SERVICE LETTER 208

13000A Hydraulic Pump Replacement

Aircraft Makes/Model(s):	Float Model(s):	Compliance: Optional	By: MAB
DeHavilland DHC-6	13000A	Part Number: 1011406	Approved: SDW
		Date: 3/5/2021	Revision: B

DISCONTINUED HYDRAULIC PUMP 13A09000-130

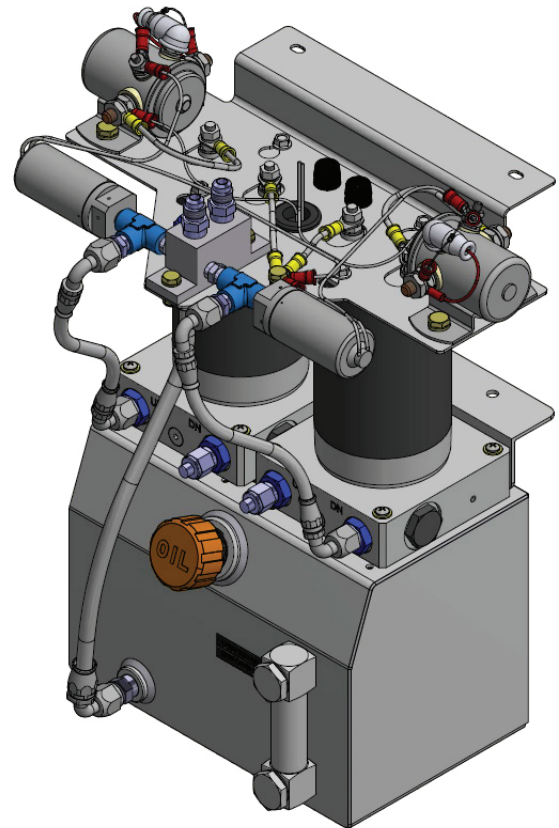
Hydraulic Pump Assembly 13A09000-130 has been discontinued. This service letter provides the option to replace it with a new pump p/n 1011370.

NEW HYDRAULIC PUMP 1011370

ELECTRICAL SCHEMATIC

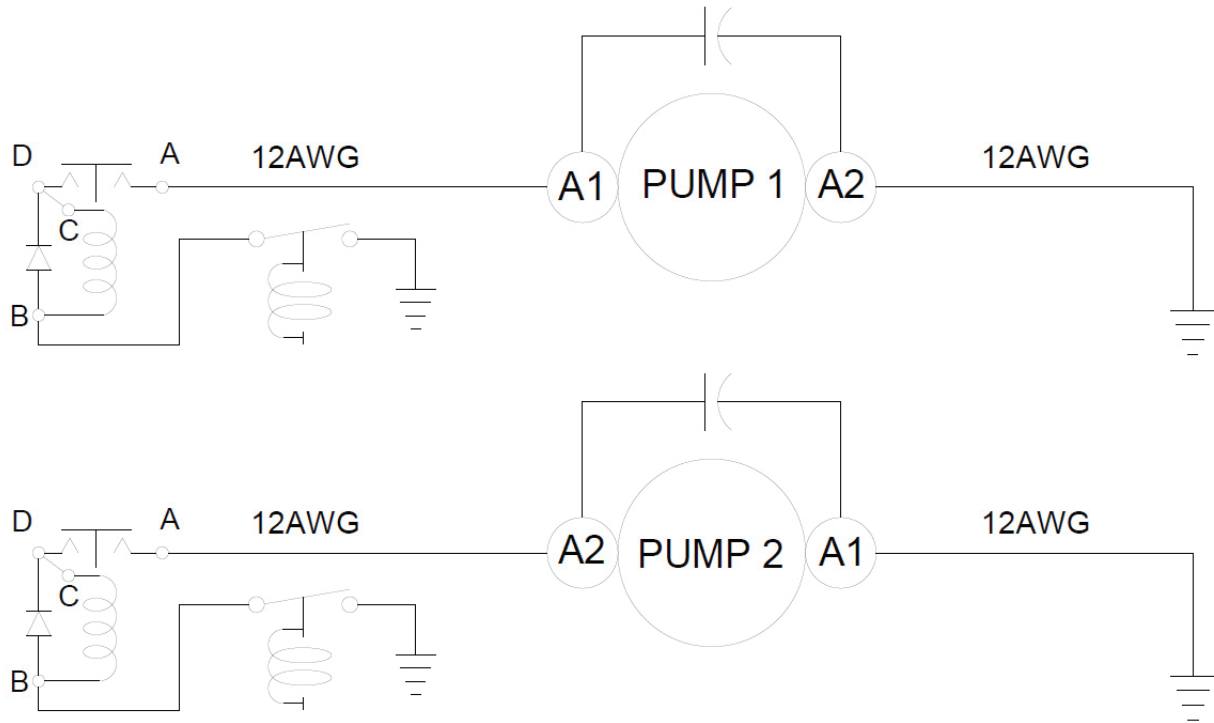
Revision	Description	Date
A	Initial release	5/7/2020
B	Updated electrical schematic	3/5/2021

7. Install pressure and return hydraulic lines to hydraulic pump manifold. Refer to hydraulic schematic.
8. Re-install GE10 and GE11 wires (20 ga) onto wires coming from fuse holder with supplied butt splice connectors. See electrical schematic.

13. Install 10 ga. wires onto 35 amp circuit breakers, and electrical solenoids on the hydraulic power pack with supplied terminal ends. Refer to electrical schematic.
